SUBJECT: Responds to 840404 request for addl info re util request for
 exemption from requirements of App R to 10CFR50 concerning
 nine floor hatches requiring fire protection drawings
 provided.

June 27, 1984
AEP:NRC:0692P

Donald C. Cook Nuclear Plant Unit Nos. 1 and 2
Docket Nos. 50-315 and 50-316
License Nos. DPR-58 and DPR-74
INFORMATION CONCERNING REQUEST FOR TECHNICAL EXEMPTIONS
FROM REQUIREMENTS OF APPENDIX R TO 10 CFR 50 FOR FLOOR HATCHES

SCREEN HOUSE HATCH DETAIL

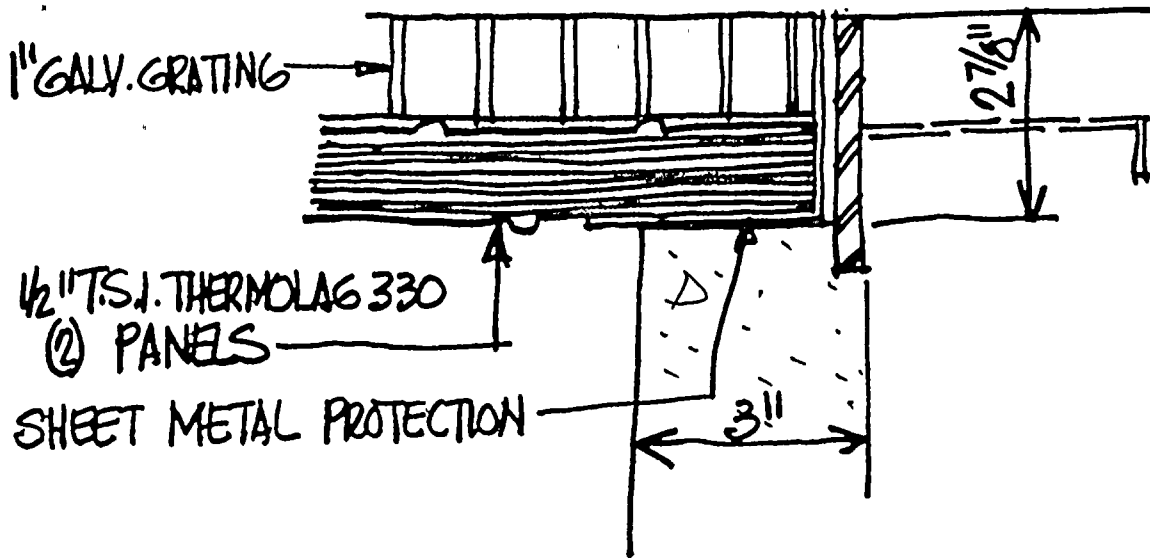
SCREEN HOUSE HATCH NOTE

STRESS SKIN TO BE ON OUTSIDE ON DWG. 12-3764

SMOOTH SURFACE ON T.S.I. MATERIAL AGAINST COX. EDGE

CHECK W/ T.S.I. ON HATCH COVER DETAIL FOR 3-H. FIRE RATING

BATTERY ROOM HATCHES

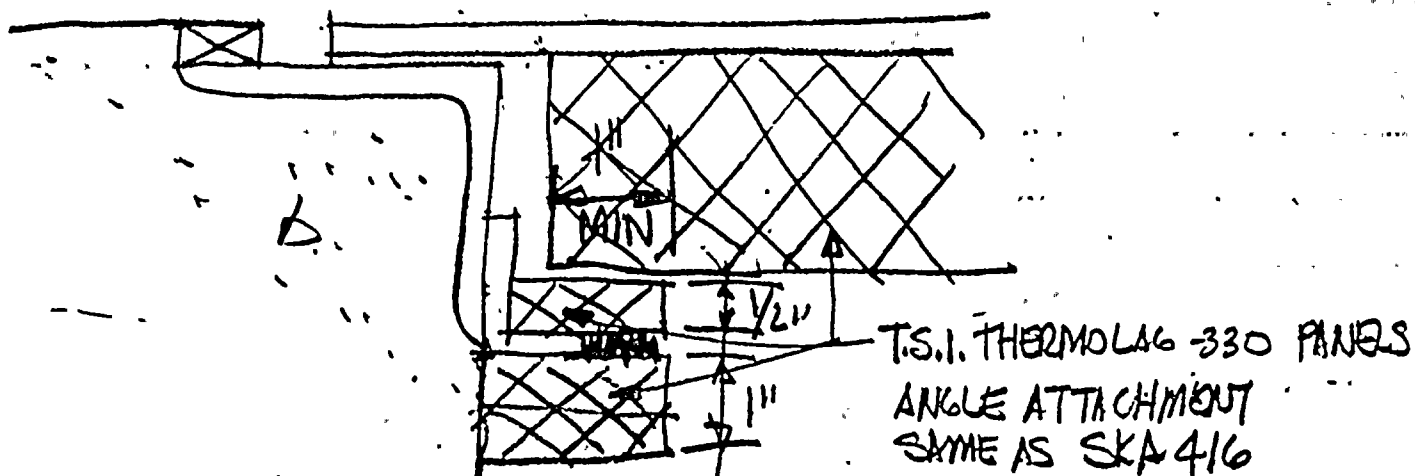
UNIT-1 BATTERY Rm. HATCH NOTES (SEE SKA 417)

⑨

⑪

UNIT-2 BATTERY Rm HATCH NOTES (SEE SKA 417)

⑨

⑪

RFCs 01-2676 & 02-2672
BILCO FLOOR HATCHES

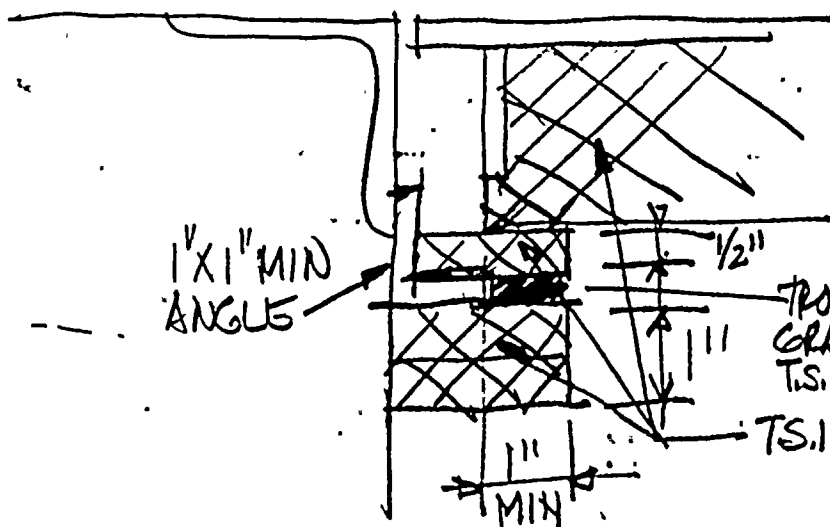
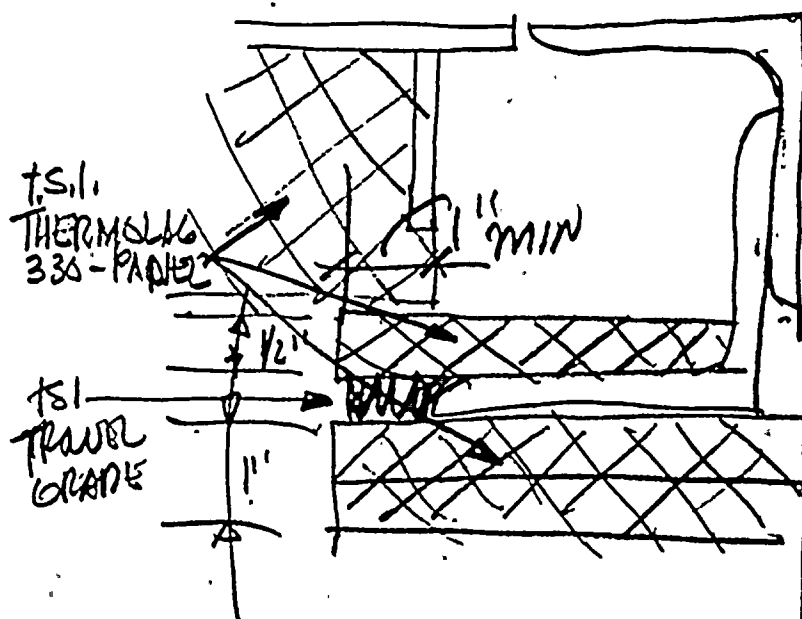
THREE SIDES ANGLE ATTACHMENT

- ① WELD -
- ② 1/4" EXPANSION ANCHORS
(3 MIN. EA SIDE)
(2" MIN. EMBEDMENT)

T.S.I. THERMOLAG 330 PANELS

HINGE SIDE ANGLE ATTACHMENT SAME AS ABOVE

FLOOR HATCH NOTES

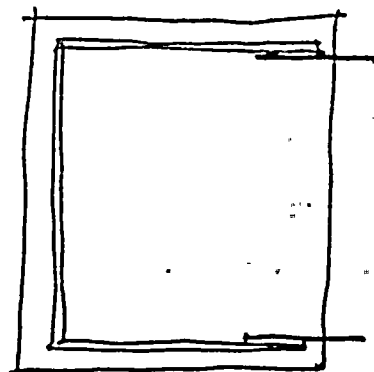
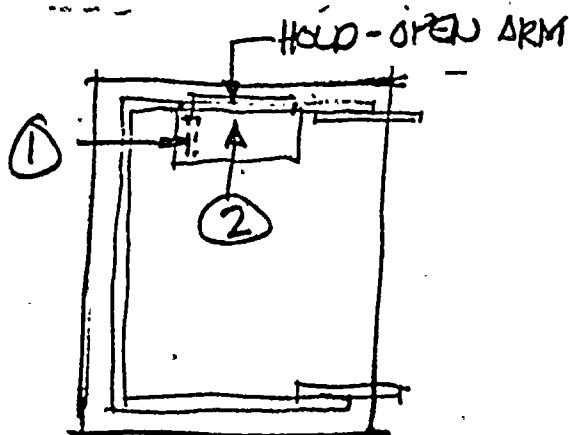
- ① REMOVE HANDLE & MODIFY HOLD-OPEN ARM FOR OPERATION
- ② FILL IN OPEN SPACE W/ T.S.I. MATERIAL
- ③ TROWEL GRADE T.S.I. MATERIAL APPLIED TO OPEN SPACES
- ④ HINGES TO BE PROTECTED WITH T.S.I. (1" MIN.)
- ⑤ REMOVE LIMIT SWITCH STOP & RELOCATE (FILL SPACE W/ T.S.I. MAT. TO ELIMINATE PREVIOUSLY ASSUMED "HOT-SPOT")
- ⑥ RELOCATE CO₂ ISOLATION SWITCH
- ⑦ LATCH HAS BEEN REMOVED - ELIMINATES PREVIOUSLY ASSUMED "HOT-SPOT"
- ⑧ REMOVE LATCH - FILL SPACE W/ T.S.I. MATERIAL
- ⑨ CERAMIC BLANKET AS FILL MAT'L BETWEEN T.S.I. PANELS IN BATTERY ROOM HATCHES. I.E.
- ⑩ CERAMIC BLANKET AS FILL MAT'L BETWEEN T.S.I. PANELS & STEEL HATCH COVERS (BILCO)
- ⑪ FILL CONC. VOIDS W/ GROUT
- ⑫ BOX-IN AND SEAL BALANCE MAGNETIC SWITCH (BMS.)
- ⑬ REMOVE GYPSUM PANEL FOR SIDE ANGLES & T.S.I. MAT'L.
- ⑭ INSTALL NEW FOLD-DOWN HANDLE
